Decision re Mann Town Highway Access Road Permit Application

I am writing to request reconsideration and clarification of two (2) provisions of the Memorandum of Decision and Driveway Permit with Conditions and Limitations issued to Andrew Mann on October 13, 2023.

Request for Clarification and Reconsideration of the Driveway Area Dimensions

PROJECT TITLE:	ANDY MANN ACCESS PERMIT REVIEW
SHEET TITLE:	SLIDE #1 - 23.1' WIDE X 23.4' DEEP WITH MANN UNDERLAY
PROJECT NO.:	2304
SHEET NO.:	2304
SLIDE #:	
DATE:	11-7-2023

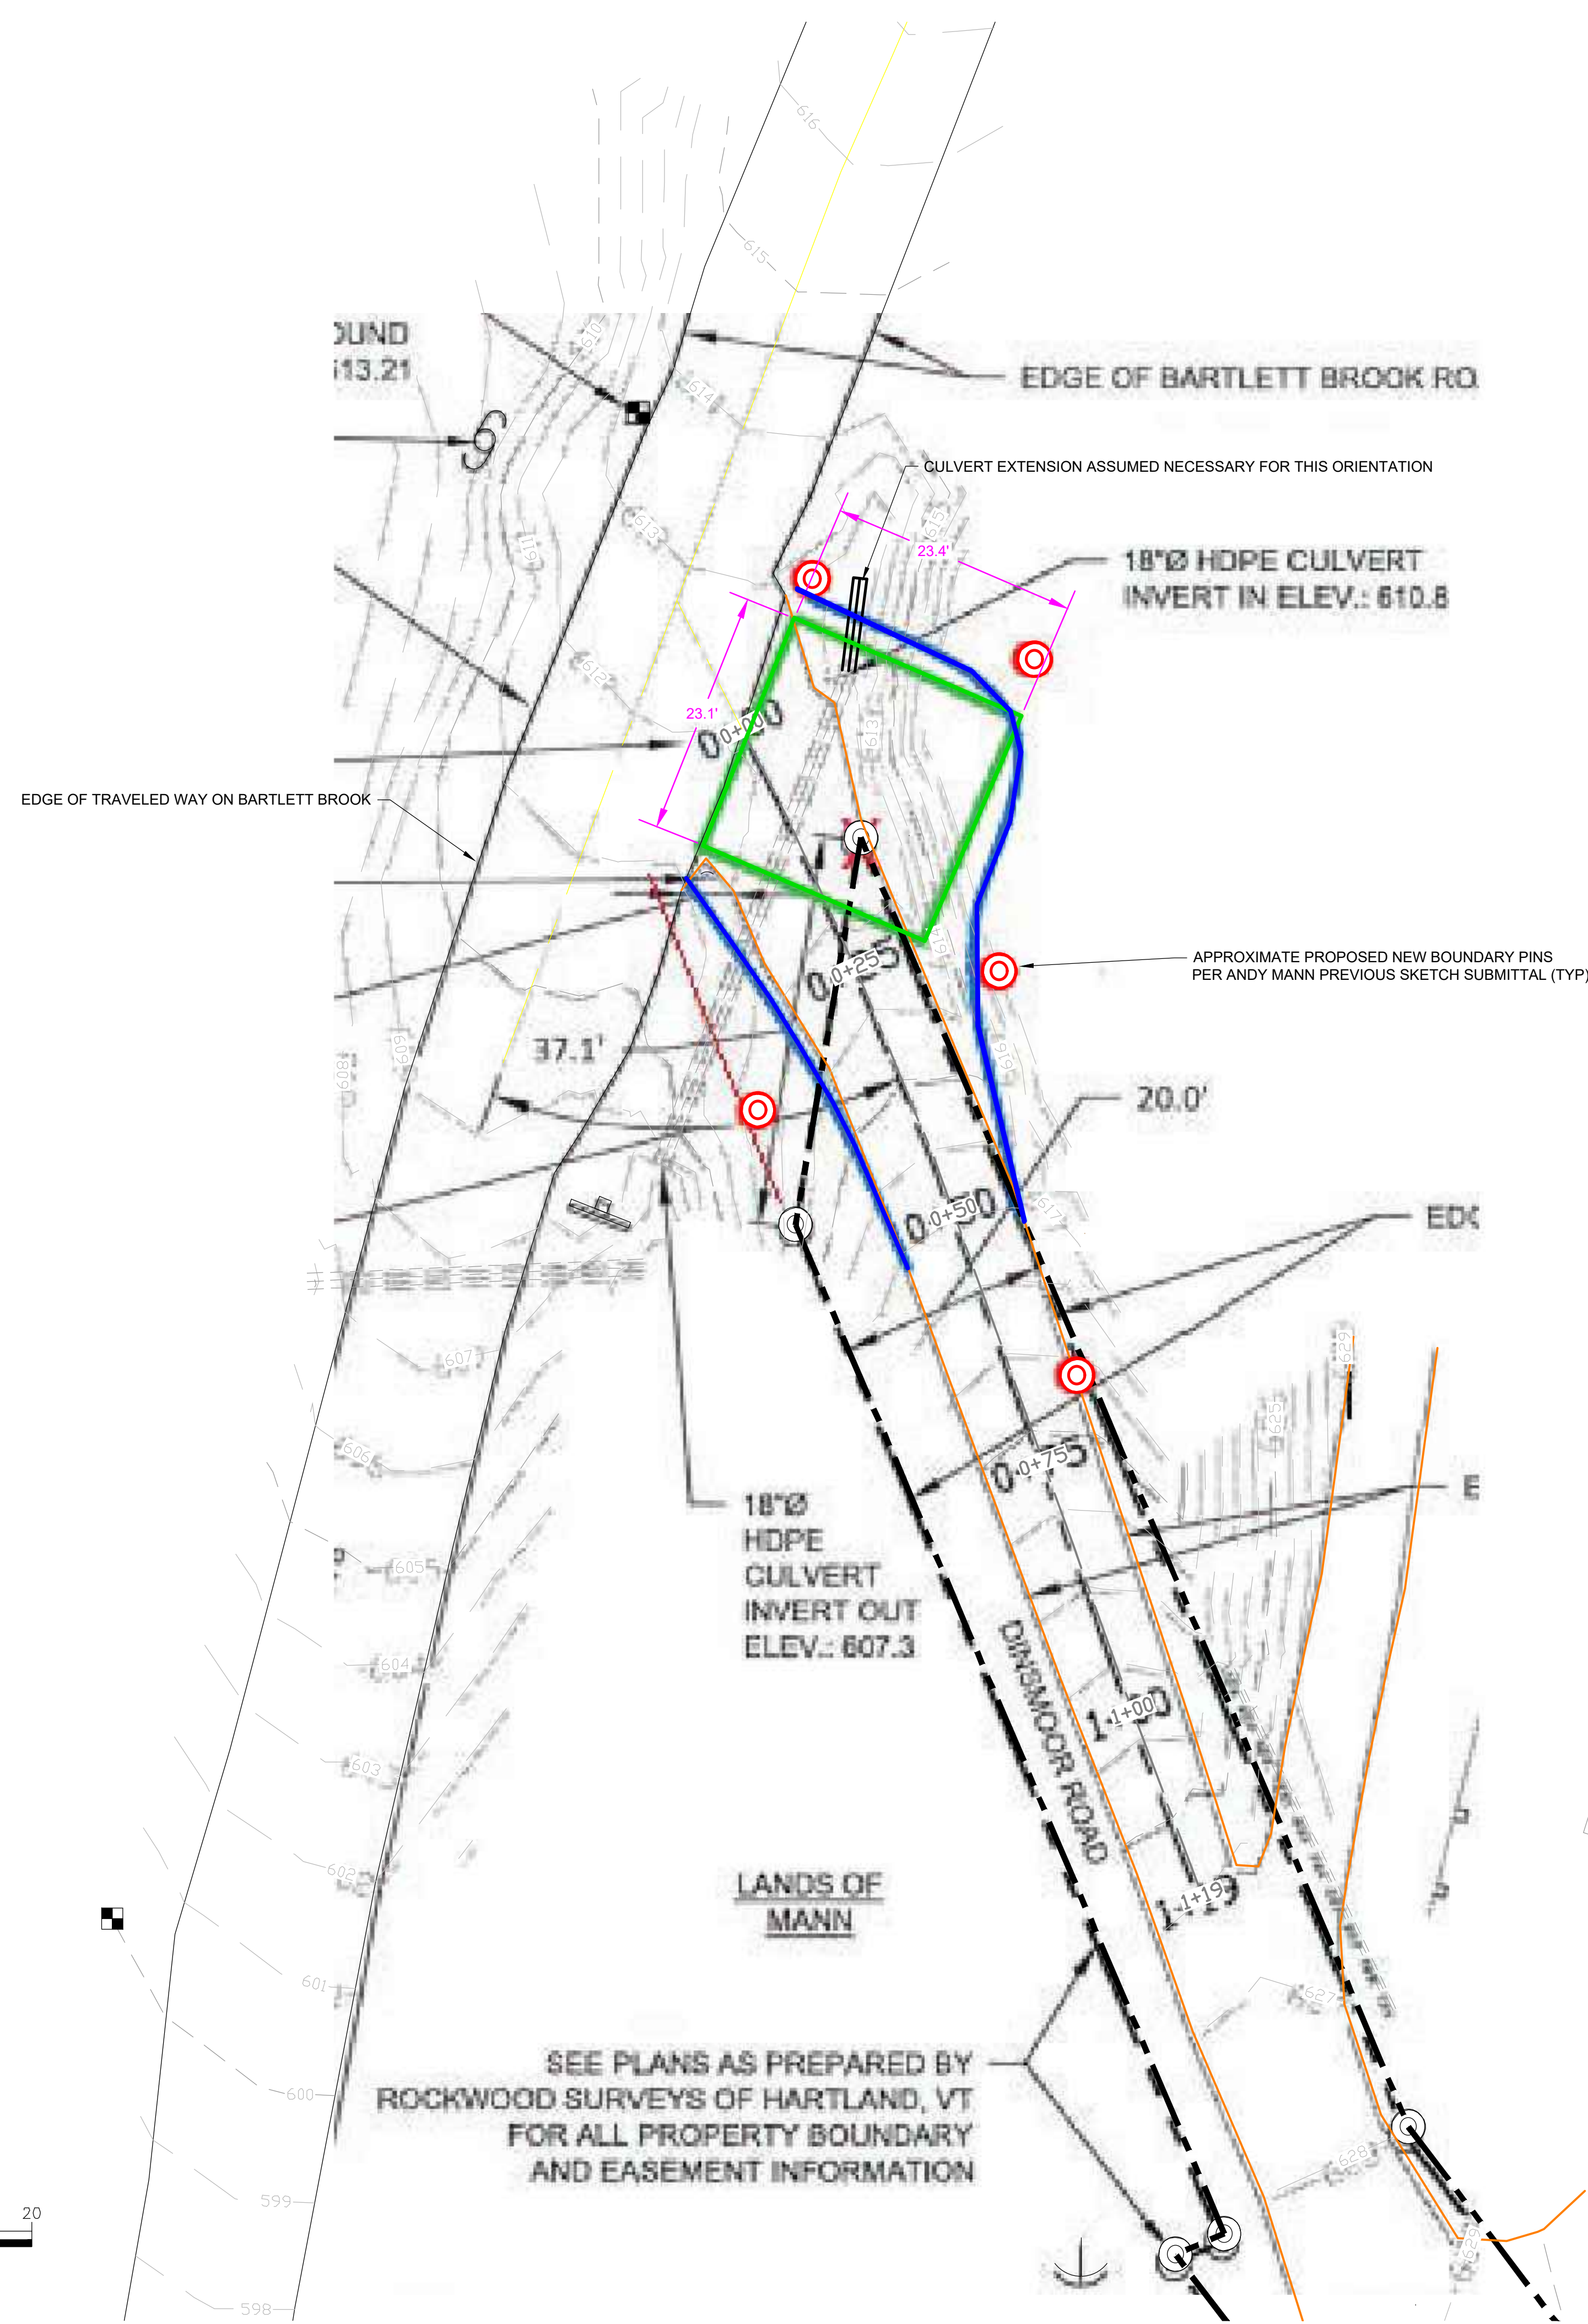
Attached as Slide 1 and Slide 2 to this request for reconsideration are CAD drawings prepared by Mr. MacKenzie. In Slide 1 Mr. MacKenzie has overlaid Mr. Mann’s Revised Site Plan onto a CAD drawing that mirrors the lines and circles Mr. Mann drew and submitted as part of his Revised Site Plan. By way of comparison, Slide 2 is the actual CAD drawing calling out Mr. Mann’s lines (and the distances he drew for the driveway area). Mr. Mann testified (13:42) that the blue lines in his Revised Site Plan represented the edges of his proposed (and approved) travel way on Dinsmoor Road. Given that testimony, and given what he submitted as a Revised Site Plan, those CAD drawings demonstrate that Mr. Mann’s Revised Site Plan actually contemplates an almost square box that is 23.1’ in width along Bartlett Brook Road and 23.4 feet deep.

It is therefore unclear: (1) what the Select Board is approving as to the specific dimensions of the green box in Mr. Mann's Revised Site Plan (if not those dimensions as Mr. Mann drew them on the Revised Site Plan and as illustrated in Slides 1 and 2); (2) if not the dimensions as set forth in the Revised Site Plan, what the Select Board expects the actual dimensions to be (both along Bartlett Brook Road and extending onto Dinsmoor Road); and (3) where the Select Board anticipates Mr. Mann locating the green box on his Revised Site Plan as between the boundaries of his proposed (and approved) new travel way of Dinsmoor road.

SHEET TITLE: SLIDE #3 - 17' WIDE X 20' DEEP HELD TO SOUTH EXTENT

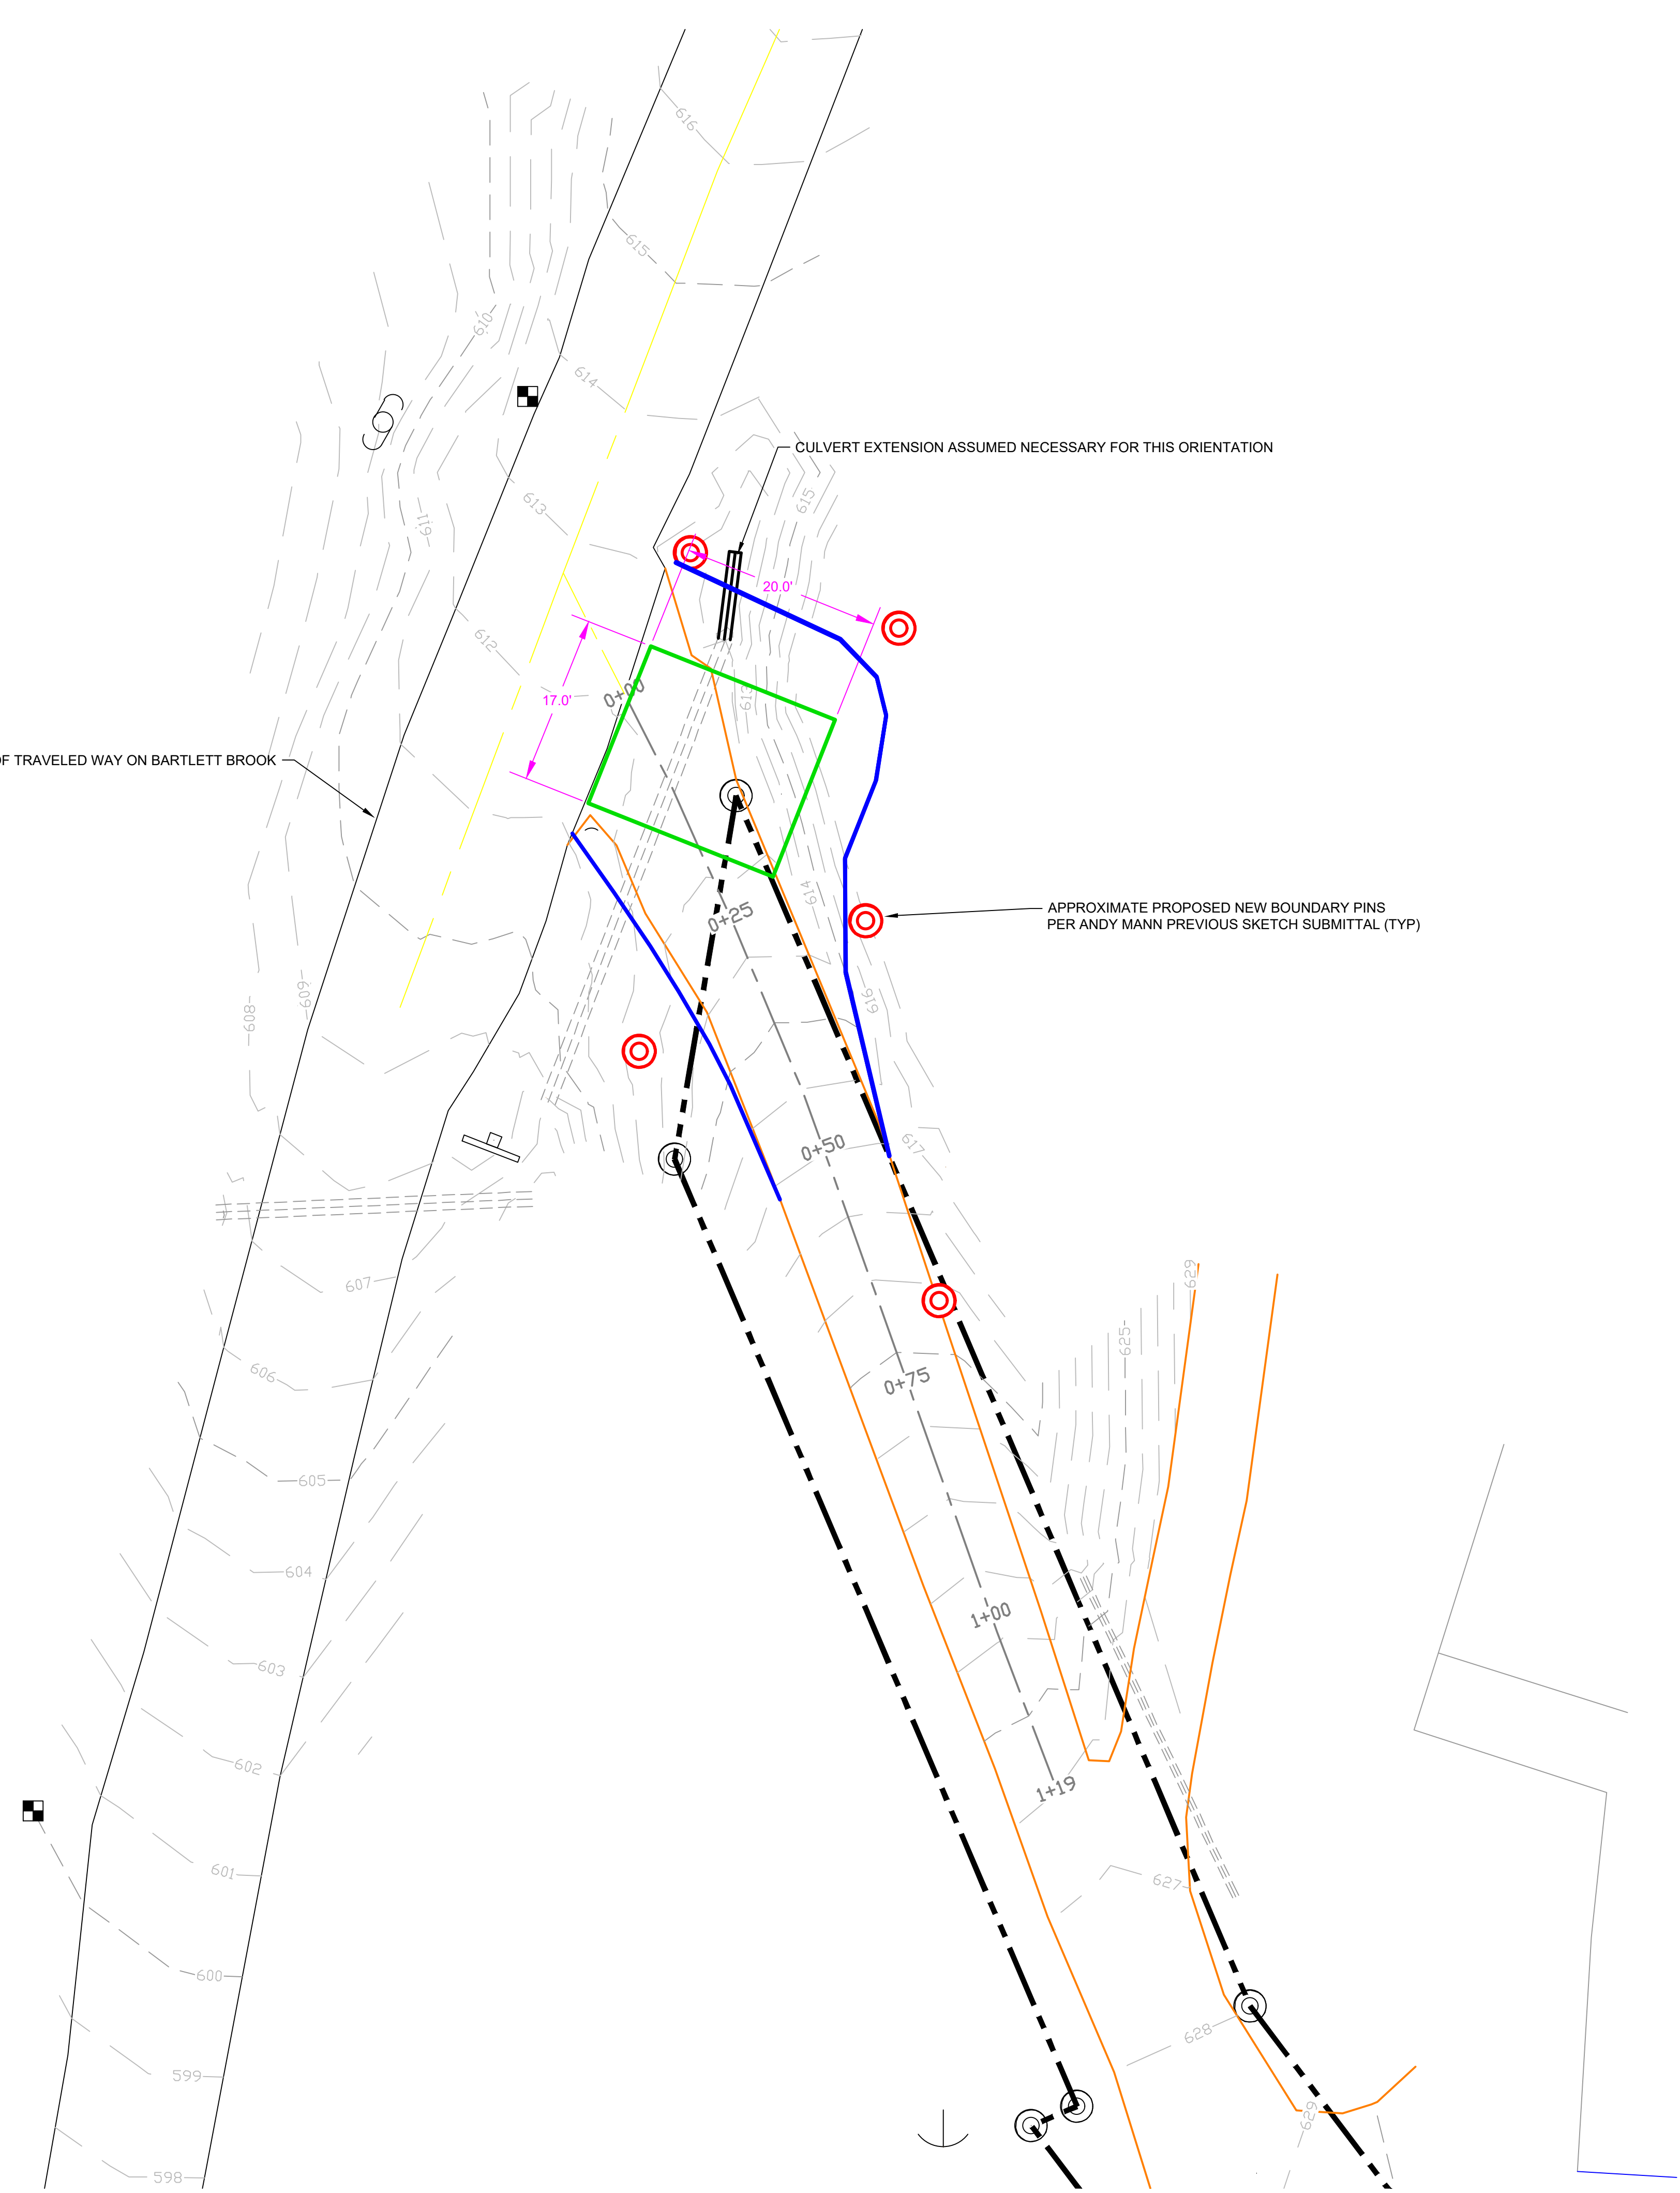
By way of illustration and comparison, attached are Slides 3 through 6. These CAD slides illustrate the location of the proposed driveway box if Mr. Mann is bound by the language of his permit application (i.e., between 17' and 19' feet wide and pitching away from the road 1' over the first 20'). As the Select Board will note, whether 17' or 19' feet wide (as set forth in Slide 3 and Slide 5), if the driveway area defined in the permit application is located at the southern end of Mr. Mann's site plan abutting his southern boundary of the proposed (and approved) Dinsmoor Road travel way, there appears to be little or no need for the extension of the culvert at the north end of Dinsmoor road, a topic of discussion and expectation at the September 13 hearing (14:42 and 28:32). The location of the green box at that point in the CAD slides is consistent with his own testimony (21:24) that the project is 85% finished and that "[t]he only part that is really going to change is the upper left hand corner [on the Revised Site Plan] where we still got to cut it back."
